U.S. Department
of Transportation
**Federal Highway
Administration**

March 6, 1998

In your February 17 letter to Mr. Henry Rentz, you requested Federal Highway Administration's acceptance of the California Department of Transportation Type 70 Bridge Rail at the National Cooperative Highway Research Program (NCHRP) Report 350 test level 4 (TL-4). To support this request, you sent us a copy of your report: "Vehicle Crash Tests of the Type 70 Bridge Rail," dated January 1998, and a copy of a video tape documenting the certification tests that were conducted.

Figure 2.22 - Test 512 Data Summary Sheet

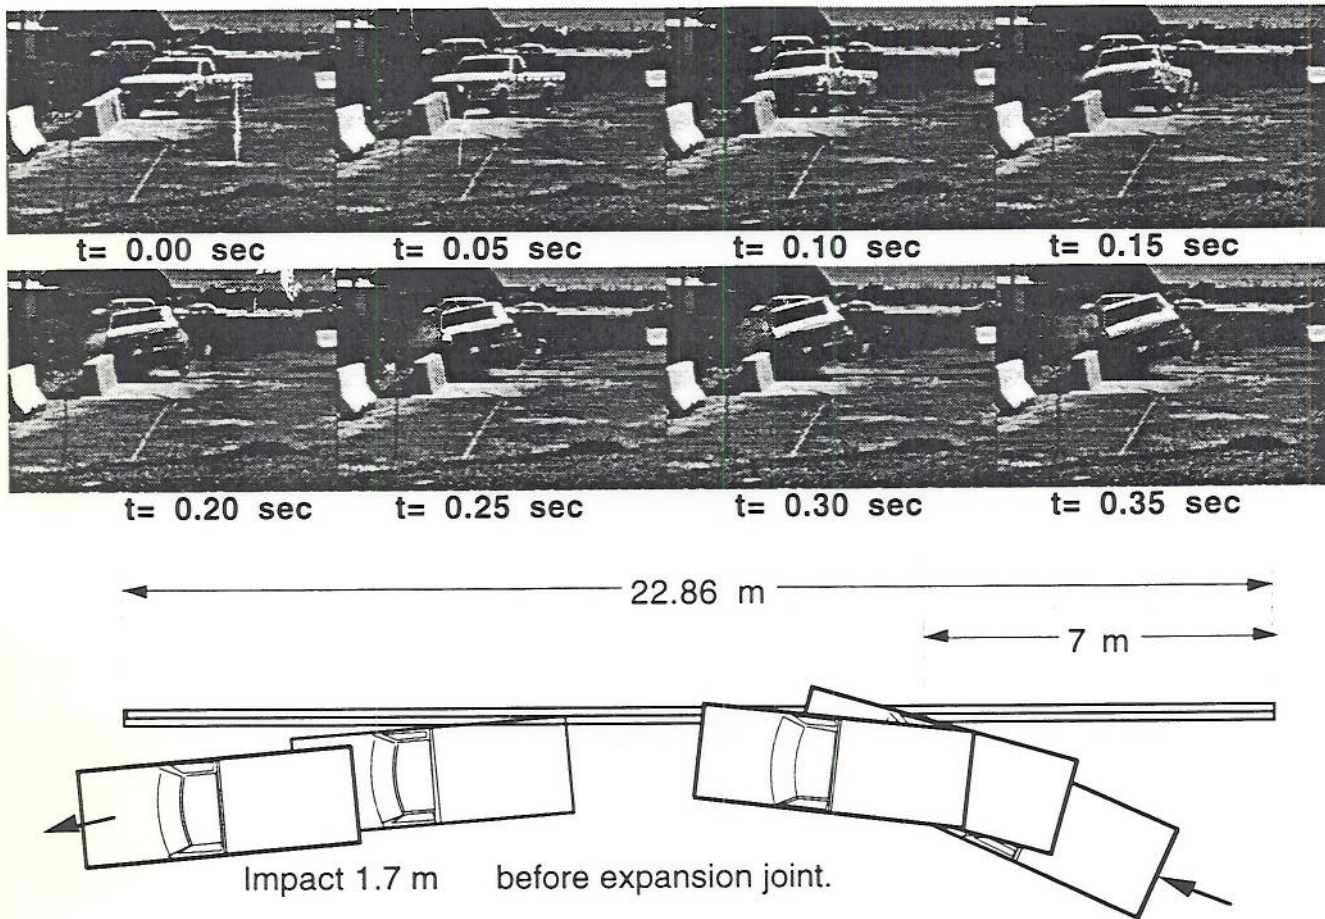
We noted that three tests were reported, including test 4-12 with an 8000 kg single-unit truck impacting the barrier at an angle of 15 degrees and a speed of 80 km/h. Each of these tests met appropriate NCHRP Report 350 evaluation criteria. The individual test results are summarized in Enclosure 2. We noted also that test 4-11 was re-run after a first unsuccessful attempt in which the pickup truck rolled over after impact. You theorized that the non-standard floating rear hub of the test vehicle caused the drive shaft to pull out of the transmission housing on impact and that the shaft then dug into the test track and precipitated the rollover. This test was then re-run with a pickup truck with a standard wheel hub. Considering the successful retest and the earlier pickup truck tests with your Type 60 constant slope barrier as well as successful pickup tests with the New Jersey, F-profile, and the Texas Department of Transportation constant slope barrier, we are willing to consider test 512 (NCHRP Report 350 test 4-11) as an anomaly.
